Revisions to Central Interchange Noise Analysis

This document contains revisions to the Noise Analysis Report, dated August 7, 2017, performed under SUM-I 76/I 77/SR 8 Akron Central Interchange, PID 101402. The revisions are limited to noise walls in NSAs 3, 4, 5, 6.

Akron Central Interchange
PID 101402
Proposed Revisions to Recommended Noise Wall NSA 5

NSA 3 Scenario 2

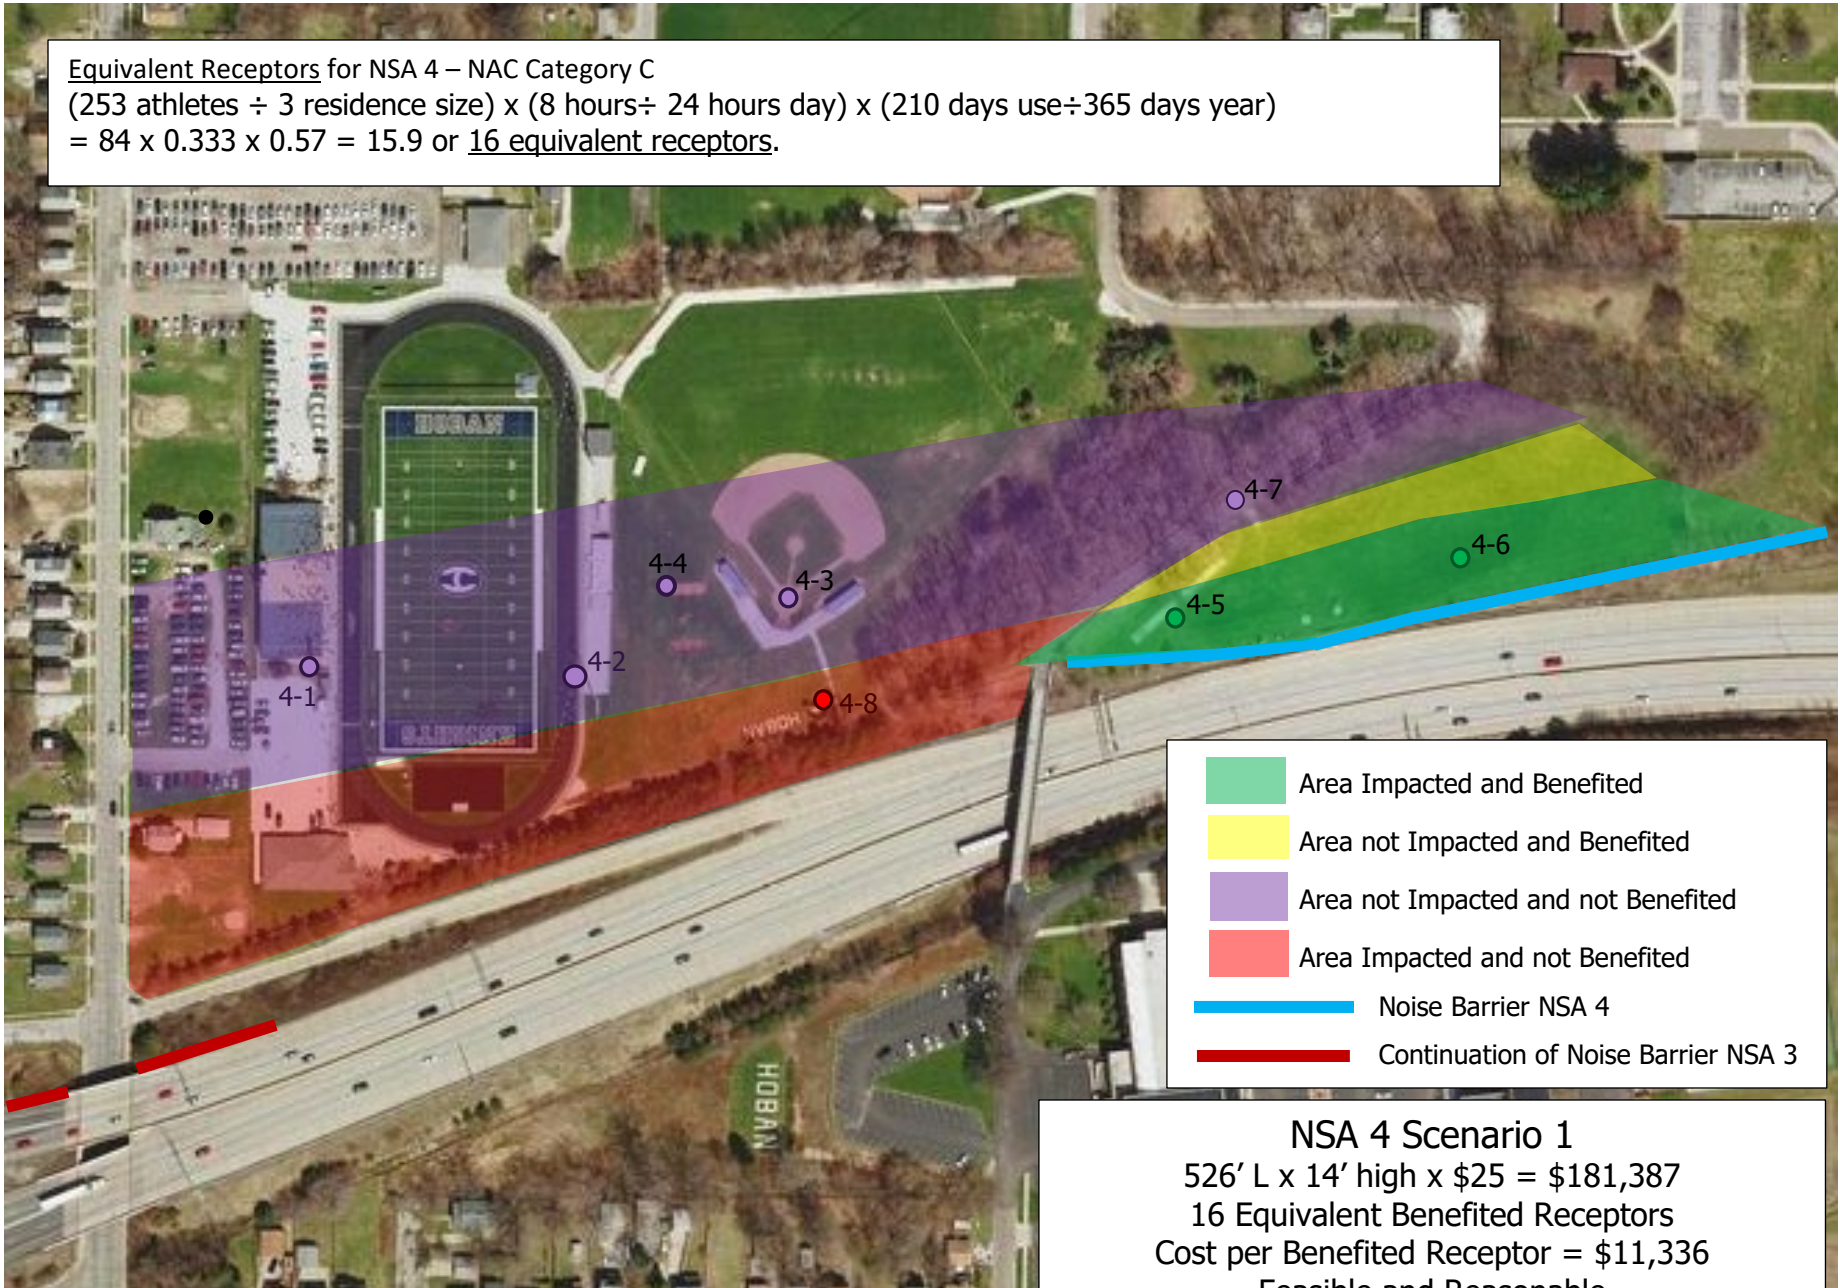
NSA 3 Scenario 2
 Noise Barrier Not on Bridge over Inman St.
 1,785 L x 16' high x \$25=\$714,081
 29 Benefited Receptors
 Cost per Benefited Receptor = \$24,623
 Feasible and Reasonable
 Recommended Scenario

NSA 4 Scenario 1

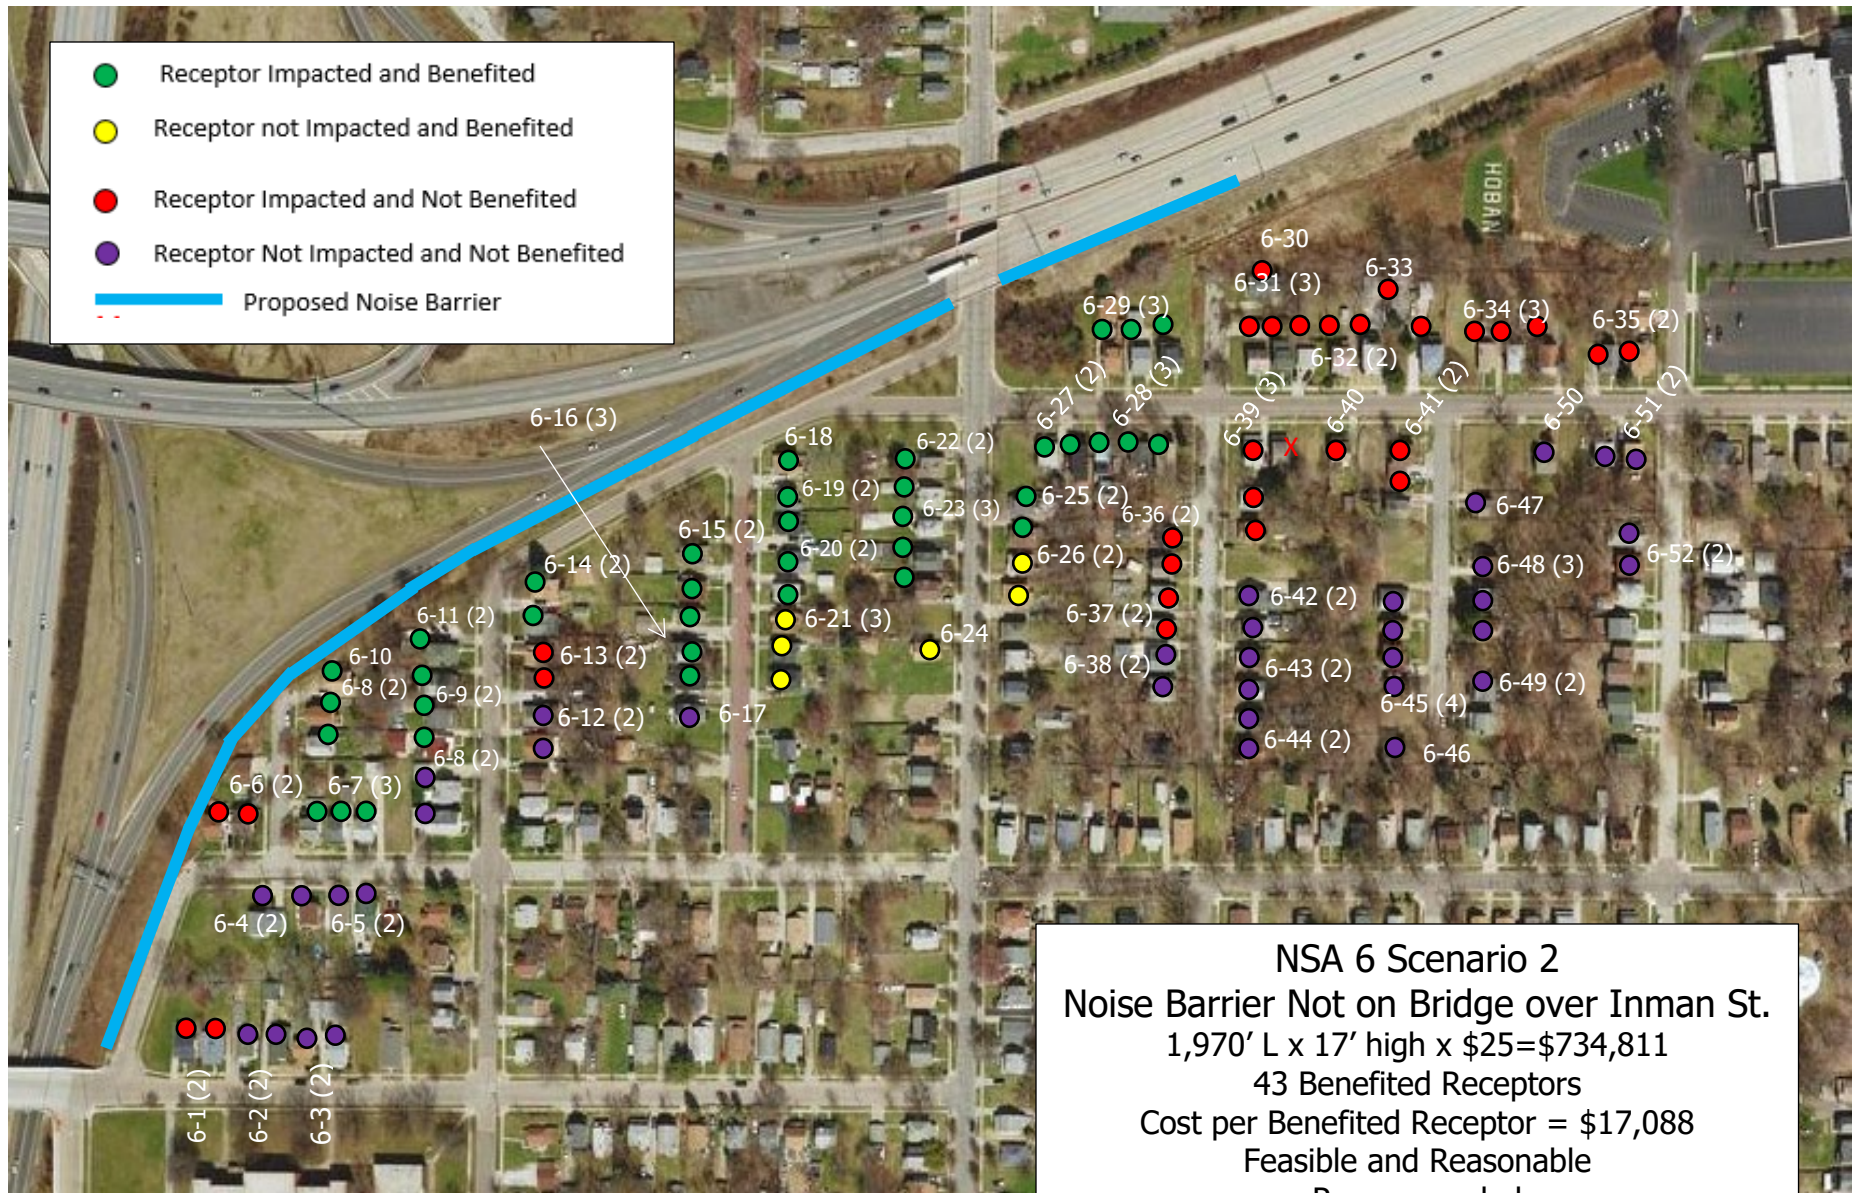
$(253 \text{ athletes} \div 3 \text{ residence size}) \times (8 \text{ hours} \div 24 \text{ hours day}) \times (210 \text{ days use} \div 365 \text{ days year})$
 $= 84 \times 0.333 \times 0.57 = 15.9$ or 16 equivalent receptors.

NSA 4 Scenario 1
526' L x 14' high x \$25 = \$181,387
16 Equivalent Benefited Receptors
Cost per Benefited Receptor = \$11,336
Feasible and Reasonable
Recommended Scenario

Exhibit C
2018 Aerial Image after completion of
PID 86979 project

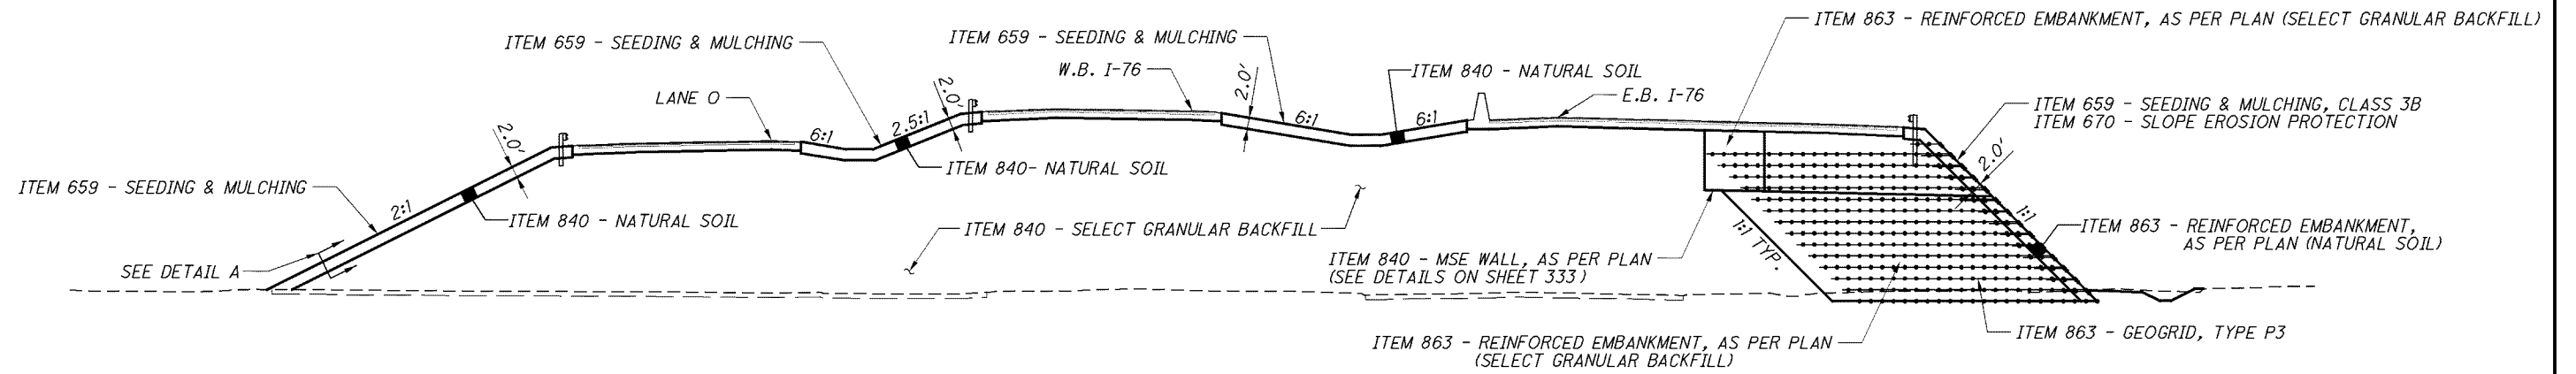
Project SUM-76/77-11.27 & 12.12 (hereafter referred as PID 86979) was recently completed in this area. As part of that project, the three existing bridges over Spicer St. and Johnston St. just east of Brown St. were removed and replaced with embankment (see Exhibits B and C).

Exhibit D

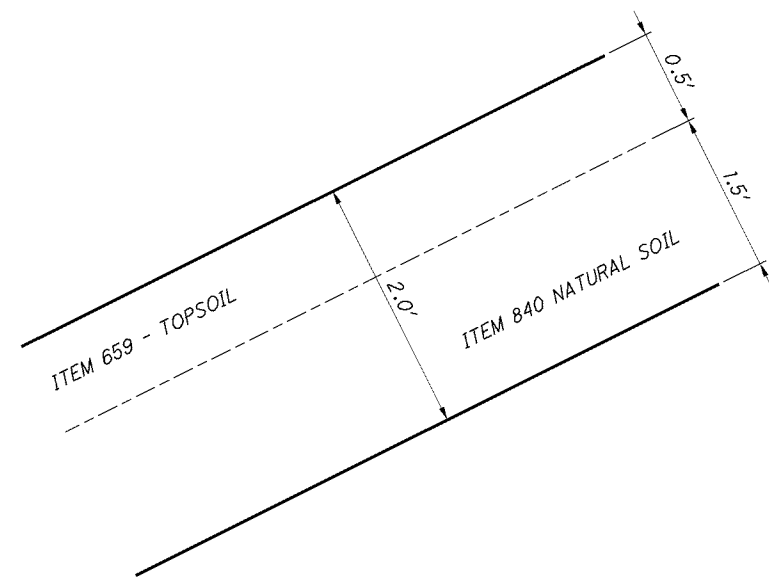
In order to reduce the footprint of the embankment, to not encroach on the new South St. cul-de-sac built as part of the PID 86979 project, a geogrid reinforced embankment was built on the south side of I-76 EB with a 1:1 side slope (see Exhibits D and E).

Constructing a conventional noise wall with conventional drilled shaft foundations is not feasible in the area where the geogrid reinforcing exists because the drilling associated with installing the drilled shafts would destroy the geogrid material and damage the integrity of the slope.

Lawhon & Associates, Inc. has prepared a supplemental noise analysis in this area assuming NSA 5 ends at the west side of the Brown St. bridge. The results of that analysis are presented in Exhibit F. Four receptors, consisting of five dwelling units, would no longer be benefited without the section of barrier east of Brown Street. The receptors that are no longer benefited are: 5-24, 5-35 (2 dwelling units), 5-37, and 5-39. The shortened noise barrier wall would still be a feasible and reasonable noise abatement measure for NSA-5.
